Illinois Power Company
Clinton Power Station
P.O. Box 678
Clinton, IL 61727
Tel 217 835-8881

Docket No. 50-461

Subject: Clinton Power Station
Proposed Resolution of Issues Related
to NRC Review of Inservice Testing Program

Revised Relief Requests

(GRAPH 1)

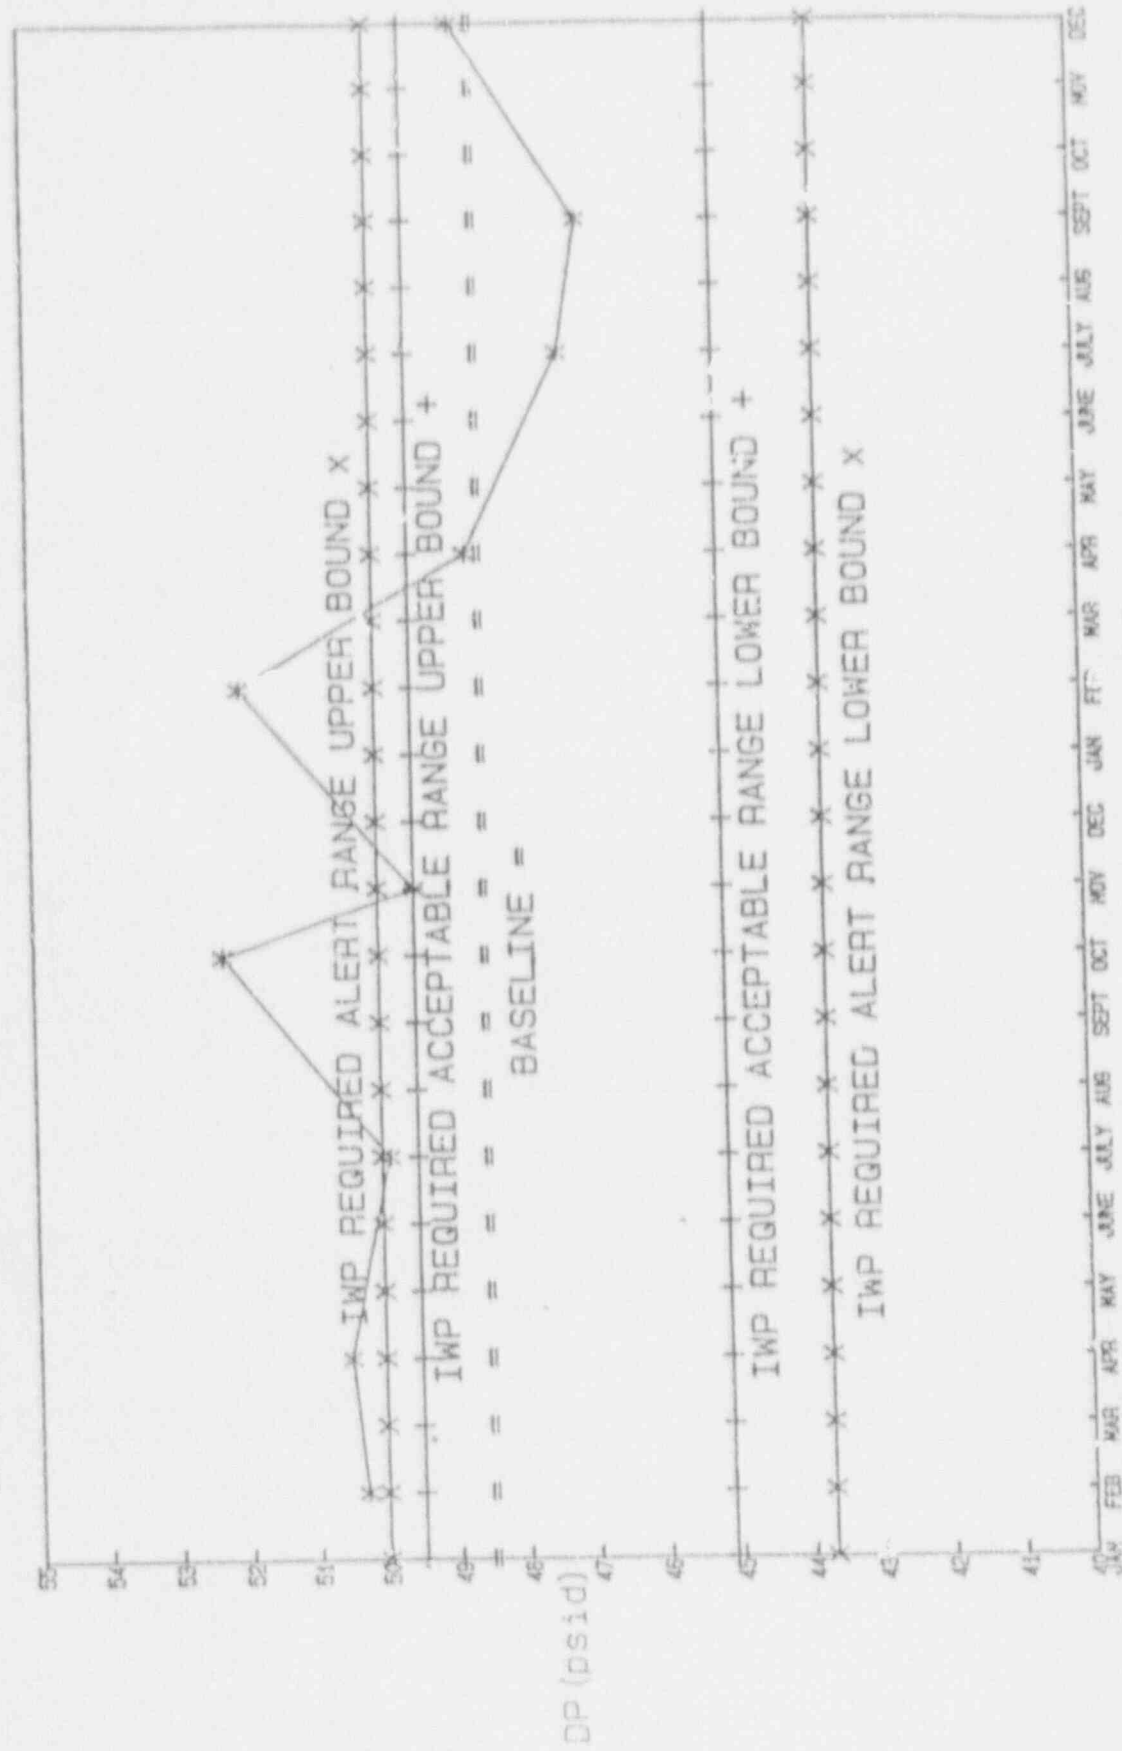
Using data for the HPCS water-leg pump (1E22-C003) as a representative example, which has a baseline DP of 48.5 psid, the Code-required acceptable range varies from 45.1 to 49.5 psid, or less than 4.4 psid (SEE GRAPH 1). Likewise the Code-required alert range for 1E22-C003 varies from 43.7 to 50 psid, for a range of 6.3 psid.

CPS believes the lower acceptable and alert range boundaries (0.93 and 0.9 of baseline DP) are achievable without undue hardship. However, based upon the Code required upper acceptable and alert range boundaries of 1.02 and 1.03 baseline DP) a deviation of only 1.0 psid above baseline DP is sufficient to force any of the CPS waterleg pumps onto increased frequency, and an increase greater

than 1.5 psid above the baseline DP will place the pumps in the action range.

(GRAPH 2)

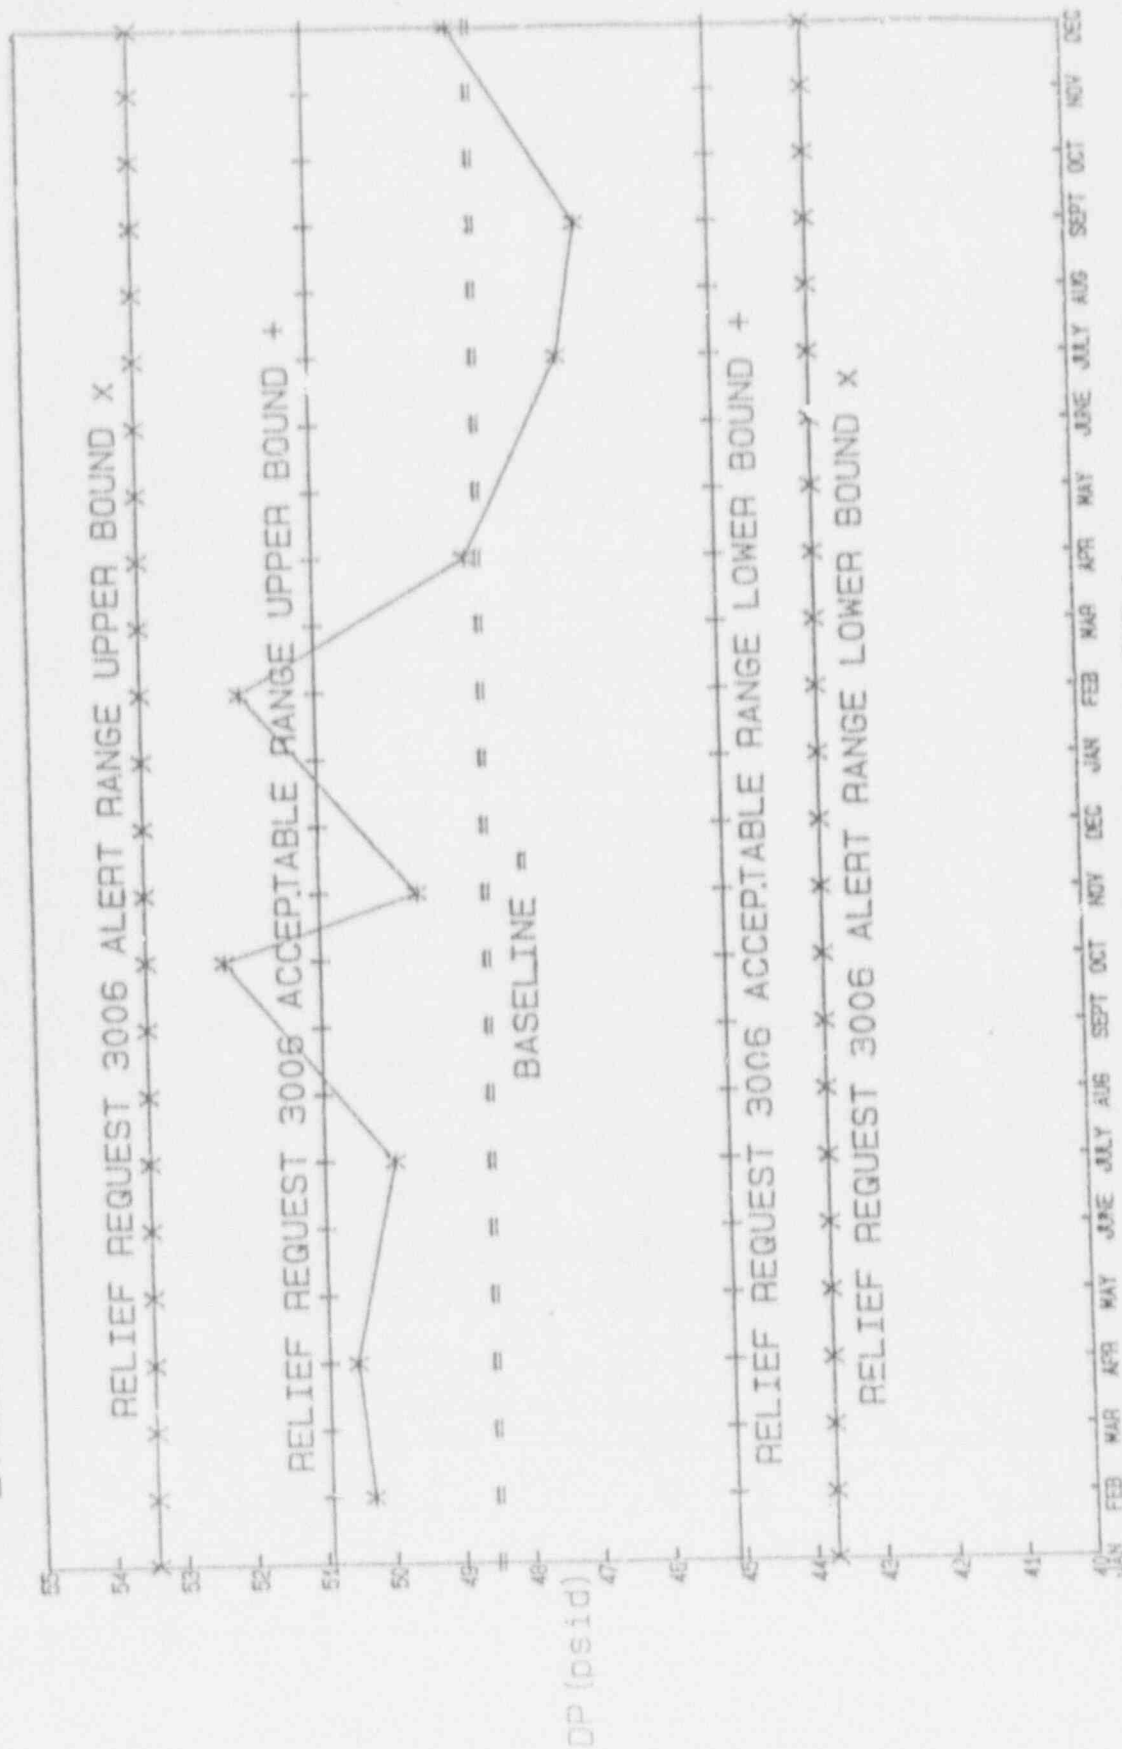
Based upon CPS's operating experience, CPS feels that the revised upper ranges will provide good indications of pump degradation without the unnecessary burden of requiring the pumps to be tested on increased frequency or declaring them inoperable for minor (1 to 2 psid) variations in DP (SEE GRAPH 2). CPS has evaluated minor fluctuations of this type and has determined that this performance is not an indication of pump degradation, and the pumps are operating within design allowable limits.

Illinois Power will utilize the following allowable, alert, and action ranges for water-leg pump differential pressure.

Acceptable Range	$(0.93 \text{ to } 1.05) \times (\text{baseline dp value})$
Alert Range	$(0.90 \text{ to } 1.10) \times (\text{baseline dp value})$
Action Range	$< (0.90) \times (\text{baseline dp value})$ $> (1.10) \times (\text{baseline dp value})$
